December 1, 2022

**RE: 2018 NC Building Code Section 1011.5.4 Dimensional uniformity**

Re: Resubmitted for Complete Response  
Request for Formal Interpretation (N.C. Gen. Stats. § 160D-1127)  
Rowan Cabarrus Community College Outdoor Classroom Phase II (the "Project")  
1333 S. Jake Alexander Blvd., Salisbury, NC

**Exhibit A**  
(to Attachment A – WCCC 8/02/22 Request for Interpretation)  
**Location Key for Stair Runs that identifies the runs of stairs on project with letters A-W**

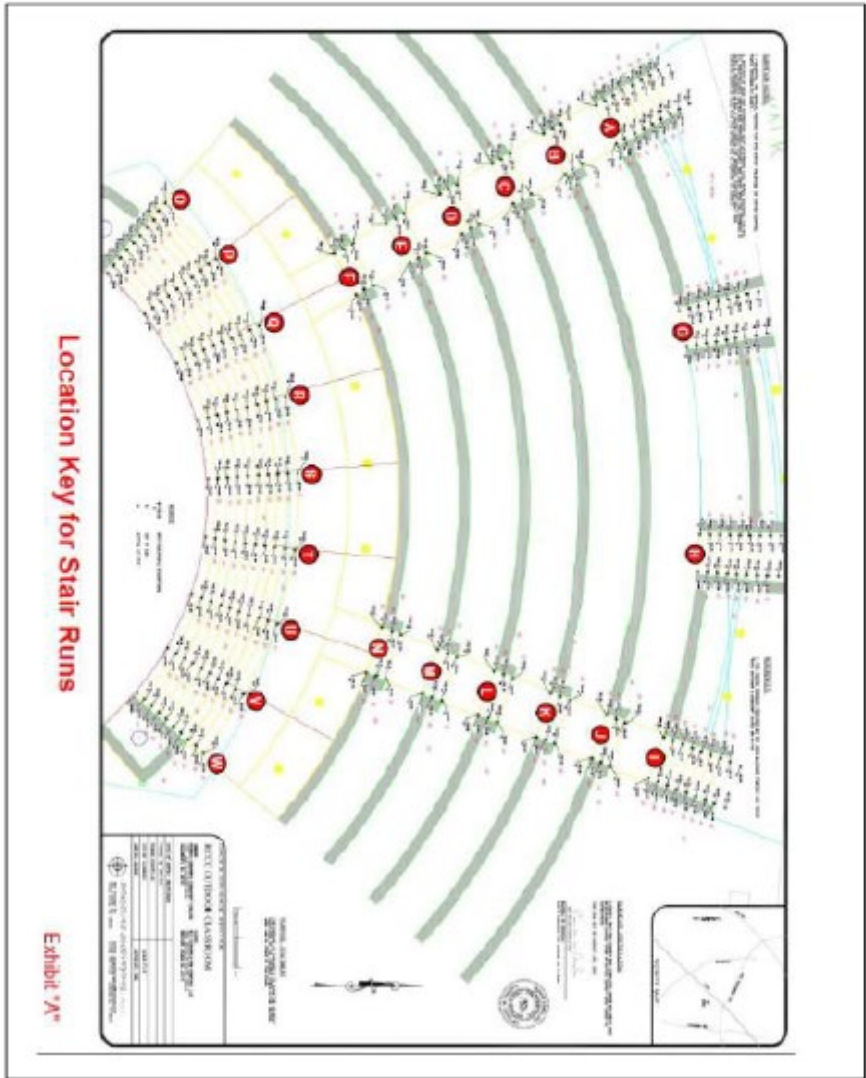
Request No. 1: Whether the steps in the aisles labeled B through F and J through N may be considered landscape steps?

Request No. 2: Without necessarily agreeing that any steps associated with the stairs and labeled O through W are considered egress steps that may not comply with the building code (WCCC expressly reserves the right to argue otherwise), to the extent that such steps are considered egress steps that do not comply with building code, can the steps be brought into compliance with the building code with the use of a barrier?"

- (2)** *Since a code-compliant means of egress system is provided via each end of the seating rows to a yard at grade level, stairs A, G, H and I are considered landscape steps. Landscape steps are not required to comply with the means of egress or accessibility requirements of the 2018 NC Building Code.*

- (3)** *As per this formal interpretation and the NCDOT Formal Interpretations dated 9/23/22 and 10/17/22, landscape steps A through N are not required to comply with the means of egress or accessibility requirements of the 2018 NC Building Code.*

- (4)** *As per this formal interpretation and the NCDOT Formal Interpretations dated 9/23/22 and 10/17/22, steps P through V are considered means of egress steps and shall comply with the means of egress requirements of the 2018 NC Building Code unless a barrier is provided to prevent use of those steps for egress from the stage. If steps P through V are used as a means of egress, then they must also comply with Section 1009.3 for accessibility. If steps P through V are not used as a means of egress, then the accessibility requirements of Section 1009.3 do not apply.*

As-built spot elevation survey, dated August 24, 2021, by Douglas Surveying, PLLC, with subsequently added text of calculations in red font by the Designer, Nick Lowe, of McAdams

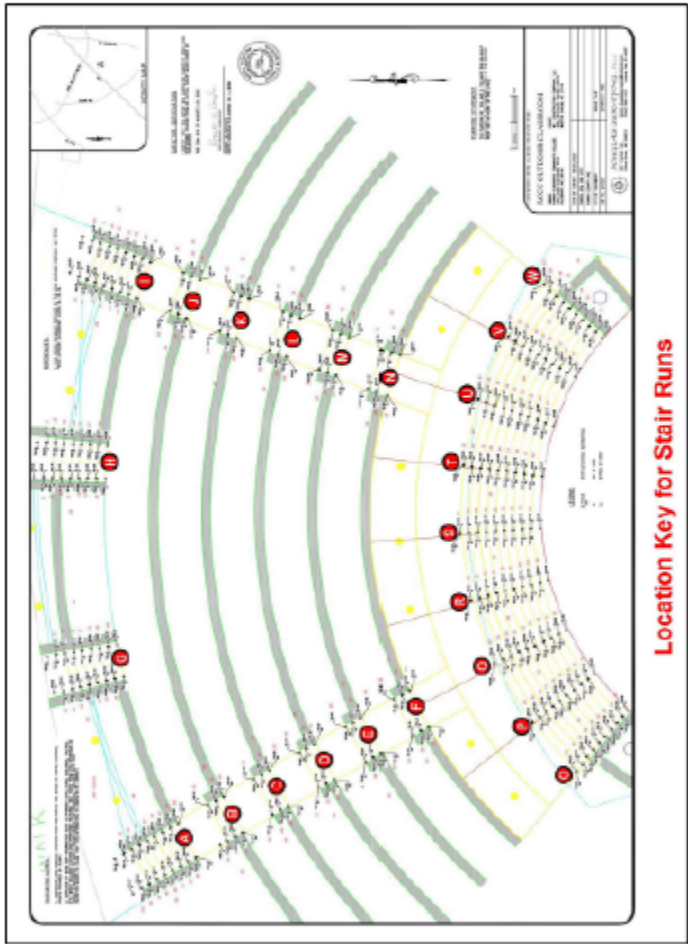
runs of steps are not code compliant based on Exhibit C to RCCC 12/16/21 Request for Interpretation - As-built spot elevation survey, dated August 24, 2021, by Douglas Surveying, PLLC (with subsequently added text of calculations in red font by the Designer, Nick Lowe, of McAdams)?<sup>2</sup>

There is a lack of uniformity in as-built riser heights throughout the project as set out in the As-built spot elevation survey we provided for reference in our Request for Formal Interpretation and version Resubmitted for Complete Response. It would be great if in your response you could determine and declare which of the as-constructed Steps A through W comply with the entire North Carolina Building Code. If you are not able to respond with a simple determination of which of the as-constructed Steps A through W do and do not comply with Chapter 11 Accessibility and elsewhere in the North Carolina Building Code, then RCCC will need to know with dimensional specificity what riser height tolerances should be used to make such a determination (adjacent risers and within a particular flights of steps). If not the riser height tolerances set out in Section 1011.5.4 (3/8 inch maximum tolerance between largest and smallest riser height in any flight of stairs) and Section 1029.13.2.2.1 (3/16 inch maximum tolerance between adjacent risers), then what riser dimension tolerances should be used to determine code-compliant uniformity?

1c. Section 1029.13.2.2.1 limits the riser height uniformity tolerance for stepped aisles to 3/16 inch unless an increase to 3/8 inch is required to "maintain adequate sightlines" for adjacent seating served by the stepped aisle. Attachment B below does not demonstrate a need for a 3/8 inch tolerance to maintain adequate sightlines for adjacent seating; therefore, the uniformity tolerance is limited by Section 1029.13.2.2.1 to 3/16 inch for the plan shown in Exhibit C.

**Exhibit D**  
(to Attachment A - RCCC 12/16/21 Request for Interpretation)  
Location Key for Stair Runs labeling on the as-built spot elevation survey all the runs of stairs on  
the project with letters A-W  
(for reference purposes only)

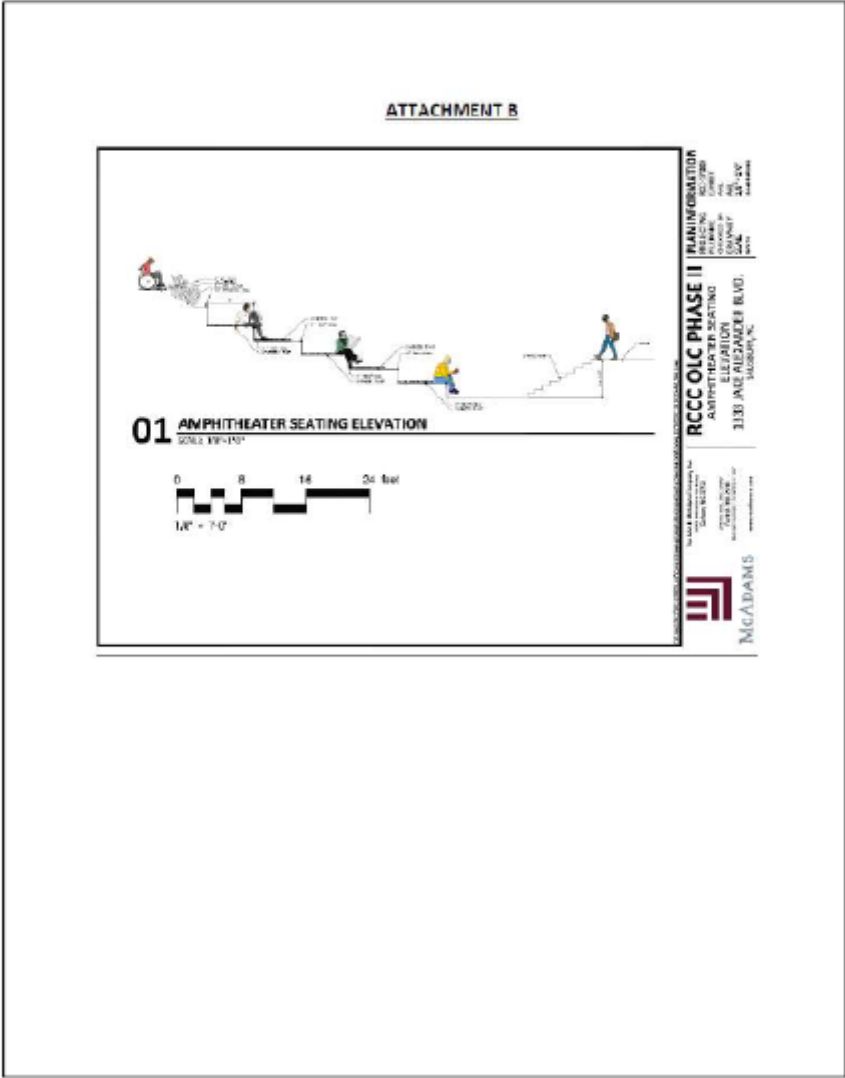
*Comment: Steps labeled A, G, H, I and O through W on Exhibit D would qualify as stairways and require compliance with Section 1011.5.*

*Comment: Steps labeled O through W on Exhibit D can have a tolerance of 3/8 inch between the largest and smallest riser. With a curved stair the intent is to meet the uniformity in any likely path of travel which, in the case of the plan shown in exhibit D of Attachment A, would be any path directly down the steps at a 90 degree angle to the top or bottom landings.*

- 1a. Steps labeled B through F and J through N on Exhibit D appear to be "stepped aisles".
- 1b. Section 1029.13.2.2.1 is the correct reference for addressing allowed riser height tolerance for stepped aisles.

**Attachment B**  
**(to Appendix #1 - NCDOI 1/6/22 Interpretation)**  
**Amphitheater Seating Elevation, by McAdams, dated December 28, 2021**

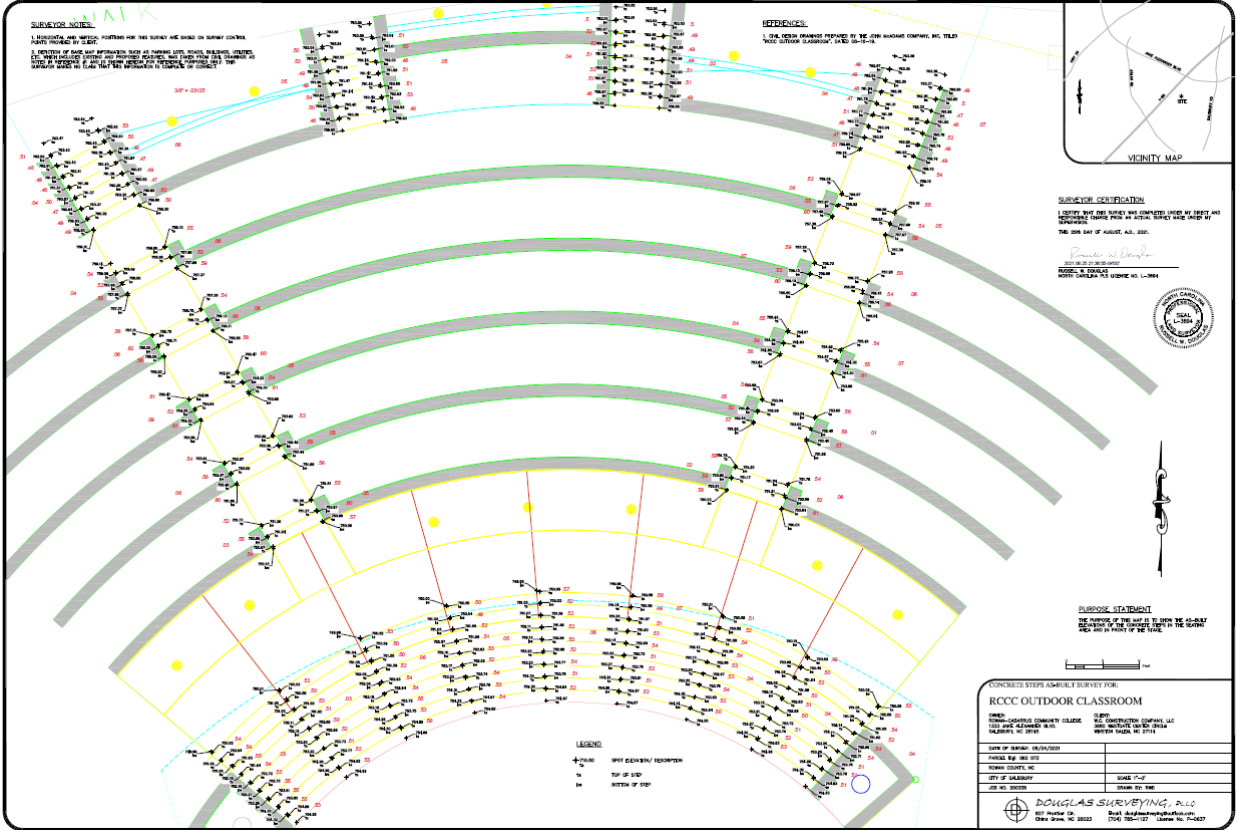
Attachment B is a drawing of the section through the site as requested by Carl Martin on December 28, 2021. The drawing was provided on December 30, 2021.
